Subject: LaSalle County Station Units 1 and 2  
Drywell/Wetwell Vacuum Breakers  
NRC Docket Nos. 50-373 and 50-374

As requested during our May 21, 1982 telecon with Dr. A. Bournia, et al this letter summarizes the presentation CECO made May 20, 1982 in Bethesda to CSB and provides further basis for our conclusion of vacuum breaker adequacy during pool swell.

GPE VALVE

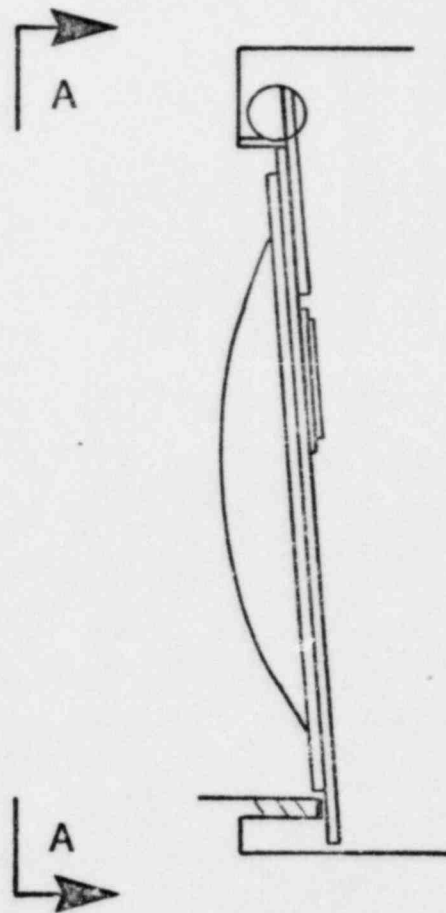
LaSalle vacuum breakers are twenty-four inch, single disk, GPE valves located in lines external to containment. These lines are isolatable both upstream and downstream by normally open butterfly valves which are manually actuated from the control room. GPE vacuum breaker valves (Figure 1) are different in design from Anderson Greenwood (AG) valves (Figure 2). The lever arm connecting the AG disk to the hinge pin transfers impact and velocity loads in a more concentrated way than the bolted GPE flange. That is, the connection of the AG arm to disk is subject to much stress. The difference in valves also makes the GPE design more favorable under impact loading because of the reduced bending moment on the GPE hinge flange compared to the AG arm.

Calculations by the Mark II Containment Owners Group predict maximum valve opening velocity of 23.6 radians/second and maximum closing velocity of 20.4 radians/second. LaSalle's valves were evaluated by analysis similar to the method used on other valve operability issues. A stress calculation on the weakest affected components (hinge pins) was performed combining all appropriate loads including velocity and impact loads of the valve disk. The velocity and impact loads were determined by a conservative hand calculation. No credit was taken for energy absorbed by elastically deformed components. Duration of impact between disc and seat was not part of the LaSalle method. The method solves for forces at the hinge pin considering the free body diagram of the valve disc just prior to impact (max. velocity) and at impact (max. seat reaction). An equation of the sum of the forces and an equation of the sum of the moments are solved as a system of equations for forces at the hinge pin effectively placing the entire reaction at the hinge pin.

This method used an impact dynamic factor of 2 which doubled the force exerted by the seat. The calculated maximum bearing stress in the hinge pin was 23,252 psi which is less than the 30 ksi yield stress allowed by ASME-Section III. Operability of the valve is assured by using a faulted loading combination and the stresses falling within material allowables for service level A. Pin deflection is negligible. A summary of the calculated forces and stresses is provided in the attached table.
